Re: El Segundo Energy Center (00-AFC-14C)

Joint Statement of Agreement on Resolution of Complaint

Joint Statement of Agreement

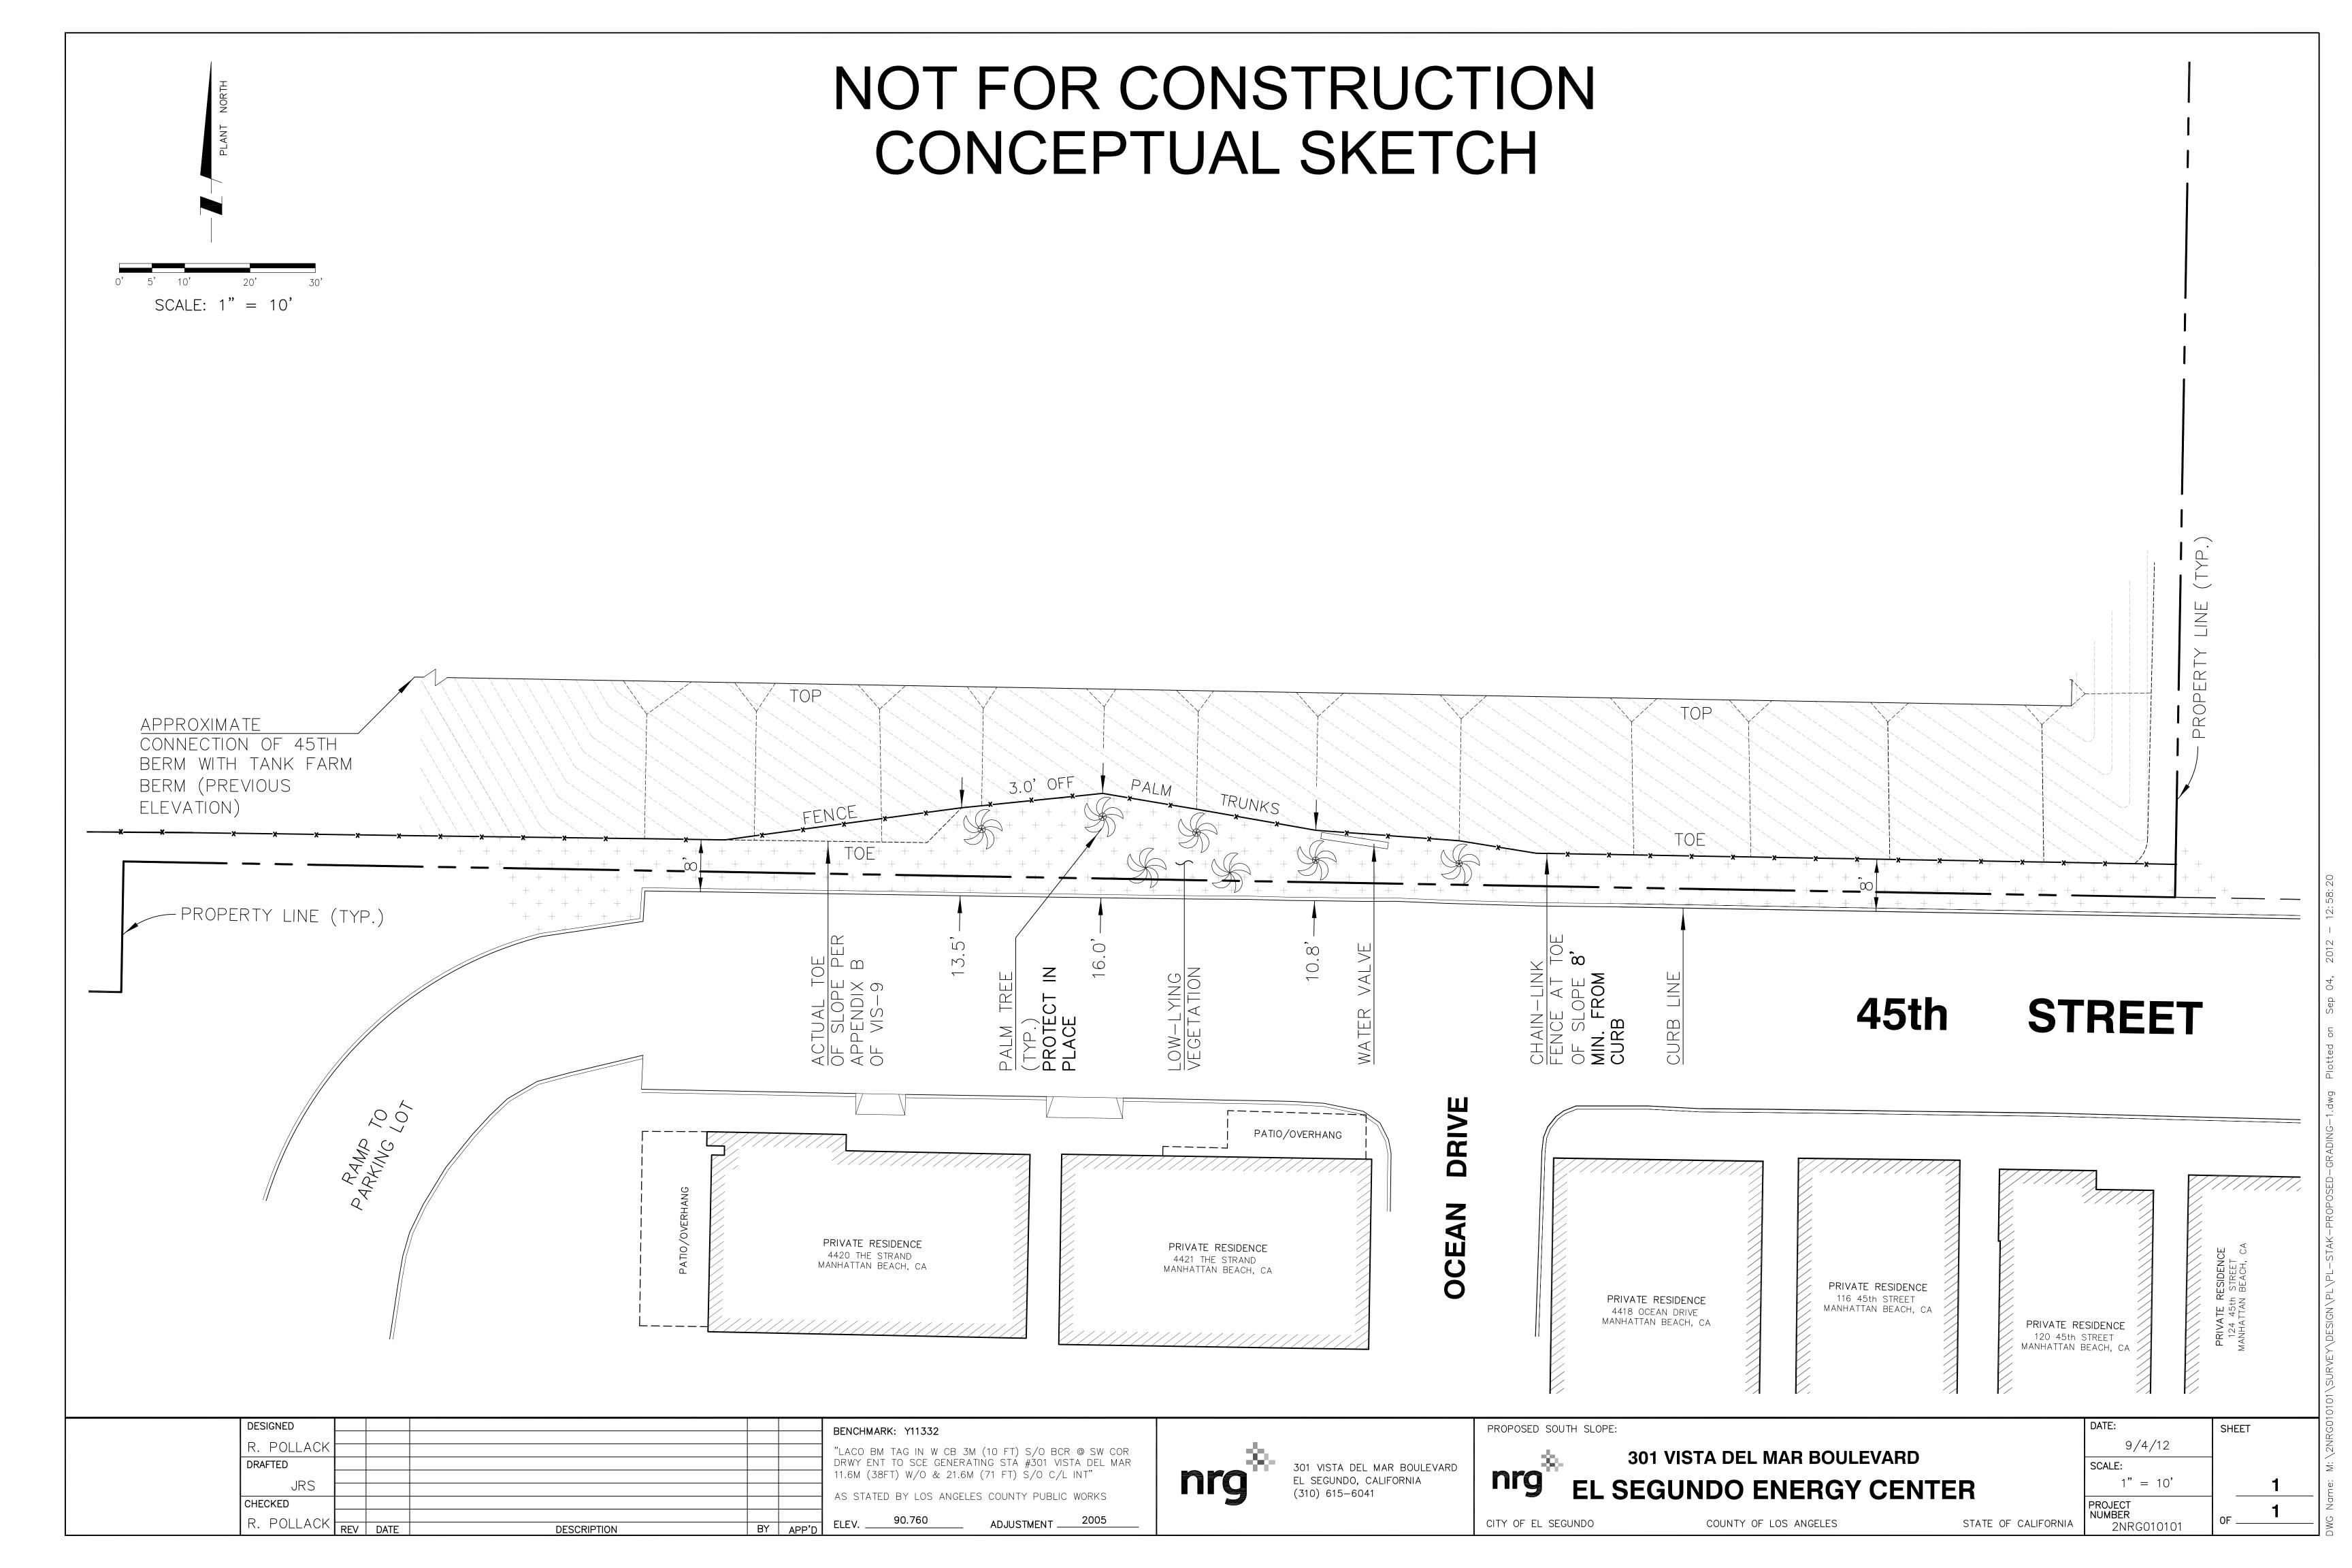
- a. The Parties jointly agree that the steepness of slope of the new 45th Street berm shall be increased in the area of the existing potable water valve and existing palm trees so the toe of the slope doe not reach the trees and that the existing palm trees shall be retained and incorporated into the landscaping. A general depiction of intended location of the toe of the slope is provided in Attachment A to this document.

- b. The Parties jointly agree that the final, permanent fence along 45th Street should be set back from the property line eight feet typical so as to maintain an area

similar to historic fence location. The Parties recognize that the exact location of the fence was never strictly decided in the past and that documents differed on its location. The Parties also acknowledge that a temporary fence on the southern property line is necessary during construction of the southern area landscaping features but that it will be replaced with the permanent fence promptly upon completion of the landscaping along the southern perimeter. A general depiction of the intended location of the fence is provided in Attachment A to this document.

- 5) ESECL agrees to prepare and submit to the City of Manhattan Beach, the City of El Segundo and the Parties for comment and then to the Compliance Project Manager (CPM) for approval, a revised 45th Street Berm Drawing (Appendix B to the *Temporary Landscaping and 45th St. Berm Vis-9* landscaping plan) that reflects the increased slope steepness to pull the slope back from the existing palm trees. The drawing should be consistent with the sketch provided as Attachment A.
